ACCESSION NBR: 8702250483 DOC. DATE: 87/02/13 NOTARIZED: NO DOCKET #
 FACIL: 50-244 Robert Emmet Ginna Nuclear Plant, Unit 1, Rochester G 05000244
 AUTH. NAME AUTHOR AFFILIATION
 KOBER, R. W. Rochester Gas & Electric Corp.
 RECIP. NAME RECIPIENT AFFILIATION
 LEAR, G. E. PWR Project Directorate 1
 LEAR, G. E. Document Control Branch (Document Control Desk)

SUBJECT: Forwards addl info re NUREG-0737, Item II.D.1, "Performance
 Testing of Relief & Safety Valves," in response to 861211
 request.

Subject: NUREG-0737 Item II.D.1, Performance Testing of Relief
and Safety Valves
R. E. Ginna Nuclear Power Plant
Docket No. 50-244

RESPONSE TO NRC REQUEST FOR ADDITIONAL INFORMATION DATED
DECEMBER 11, 1986

FIGURE 1: VALVE 434
(SHOWN ROTATED INTO PLANE)

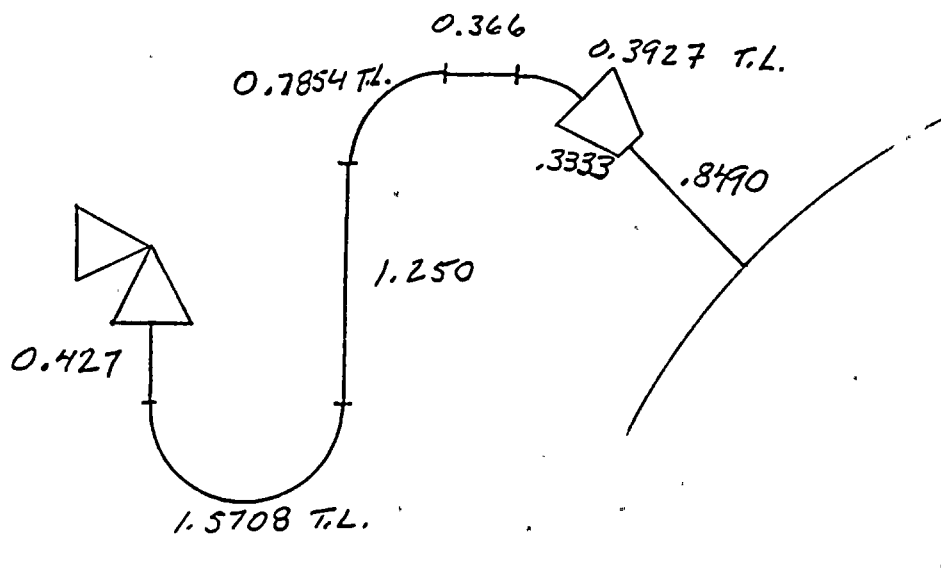
The appendix of RG&E's March 4, 1983 (Reference 1) submittal showed the calculation of the inlet piping pressure drop for the Ginna safety valves. The pipe length used in the calculation of the acoustic wave pressure drop was 3.3 ft (from Table A-1 of the appendix). Figure 2-2 in the main body of the same report, however, shows the safety valve inlet piping length to be at least 4.93 ft. This is not the total piping length since the length of at least one portion of the piping was not shown. The additional length could make a significant difference in the calculated acoustic wave pressure drop. Also the calculated flow pressure drop in the same appendix did not account for the 90° bend when calculating the L/D term. Provide the corrected pressure drop with this bend accounted for using the equation found in Rev. 2 of the EPRI Submittal Guide (Reference 2).

A review of the pressure drop calculation did uncover discrepancies between the calculation model and the as-built piping configuration. A revised pressure drop calculation has been performed in Attachment 1, using the procedure found in Appendix B of the "EPRI PWR Safety and Relief Valve Test Program Guide for Application of Valve Test Program Results to Plant-Specific Evaluations", Revision 2.

1. Valve 434

$$.8490 + .3333 + .3927 + .366 + .7854 + 1.250 + 1.5708 + .427 = 5.974 \text{ ft.}$$

$$.8490 + .3333 + .366 + 1.250 + .427 = 3.225 \text{ ft.}$$

$$3. \quad L/D = \frac{3.225}{.287} + 10.67 + 20 + 33.33 = 75.24$$
